SERVICE BULLETIN

ISSUE DATE: **3/94** MODEL: **7CCO-RV**
REVISION DATE: -

SUBJECT: **Timing Mark**

NO. **525**

Figure 1. Timing Mark Position on Engine Backplate

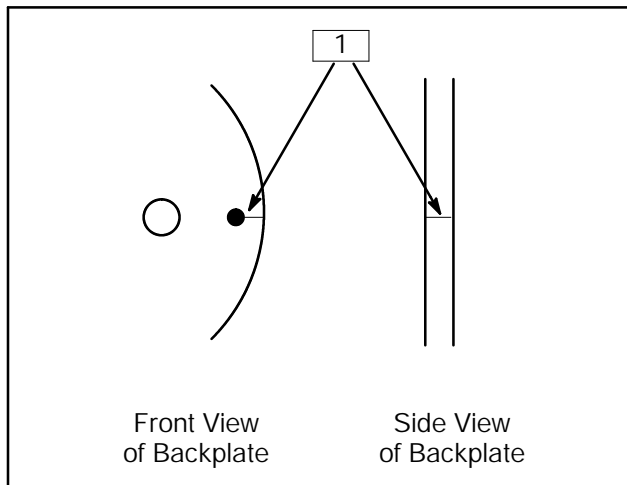
On 7CCO-RV models prior to serial number 340414 the engine timing mark may be incorrect. Verify the timing mark location before replacing any fuel injection components.

3. Locate the timing mark on the engine backplate. See Figure 1.
4. Draw a scribe mark on the backplate to the edge of the plate. Highlight mark using a metal marker or paint. See Figure 2.

5. Reassemble the stator assembly and end bracket using the generator set service manual procedure. Do not attempt to line up the scribe marks.
6. Where the new scribe mark on the backplate meets the stator assembly, scribe another mark on the outside frame of the stator assembly. Highlight the new mark using a metal marker or paint. This will be the new timing-mark reference.
